Technical Service Bulletin

Subject: FRONT SEAT CUSHION TRIM COMING OFF AT BOTTOM OF REAR SIDE - (MANUAL SEATS ONLY)	Bulletin No.: 09-013/18
	Last Issued: 03/22/2018

2017 CX-5 vehicles equipped with manual seats with VINs lower than JM3KF*****170897 (produced before June 15, 2017)

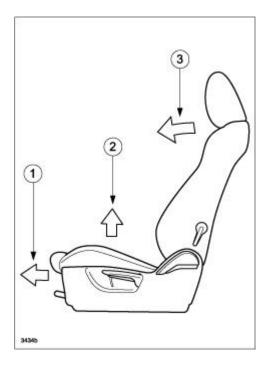
Some customers may complain about the driver and/or passenger rear side seat cushion trim (1) coming off the seat cushion frame (as shown below).

The front seat cushion trim (bottom rear) is attached to the seat cushion frame using a hook. The hook may slip out of the seat cushion frame due to insufficient strength. To eliminate this concern, a plastic tie-wrap has been added to increase the strength.

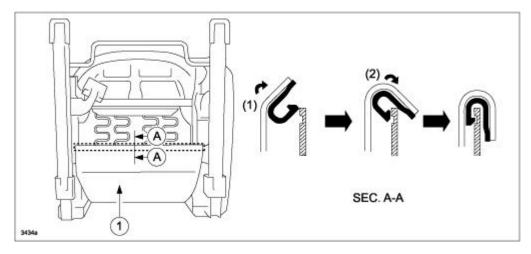
- 1. Verify the customer concern.
- 2. Move the affected seat to the forward-most (1) and upper-most (2) positions.
- 3. Tilt the seat back fully forward (3).

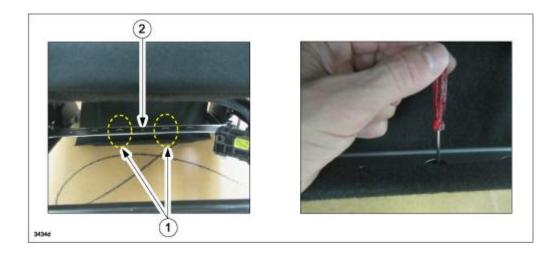
5. Using a small screwdriver (or similar tool), pierce a hole through the seat trim of one of the large seat frame holes (1) as shown below. Either large hole (1) is ok to use.

NOTE: Do not pierce the smaller hole (2).

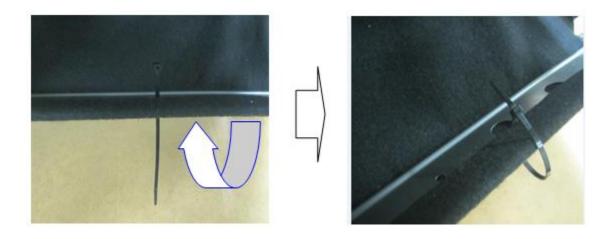
6. Tie the trim and the seat cushion frame together with one (1) locally sourced 8" black tie-wrap.

NOTE: Do not pull the tie-wrap completely tight.
